NOTICE OF MEETING

1. **APOLOGIES FOR ABSENCE**
2. **DECLARATIONS OF INTEREST**
3. **CONSIDER NOTICE OF REVIEW REQUEST: DUNEIRA, PIER ROAD, RHU, HELENSBURGH (REF: 20/0007/LRB)**
 - (a) Further Information from Planning and Roads (Pages 3 - 20)
 - (b) Comments from Interested Parties (Pages 21 - 28)
 - (c) Comments from Applicant (Pages 29 - 32)

AB7 Response.**Review Reference Number****20/0007/LRB****Reference Number Of Planning Application 19/01573/PP****Address Of Review Property****Duneira
Pier Road
Rhu
Helensburgh**

Comments on Additional Info Provided

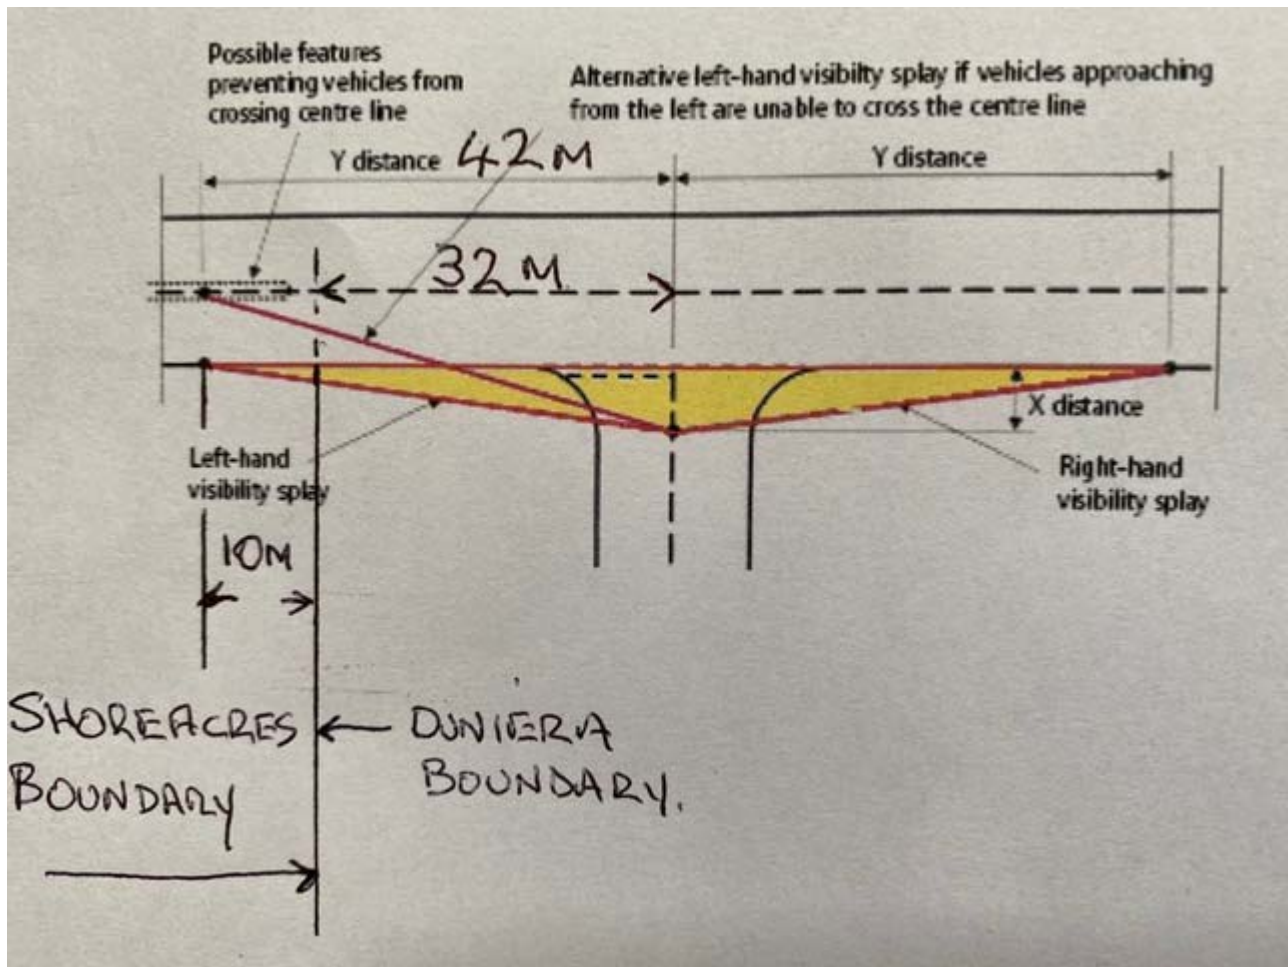
I also support the Roads Department insistence that the entry and exit must be from the A814 and that a separate planning application should be made showing alterations the the property gates to comply with regulation sight lines and splays of 42 meters.

However the chart below shows that Duniera has only 32 meters to its boundary and therefore a further 10 meters of neighbouring Shoreacres property would be required to be given over to meet the regulation 42 meters that is required.
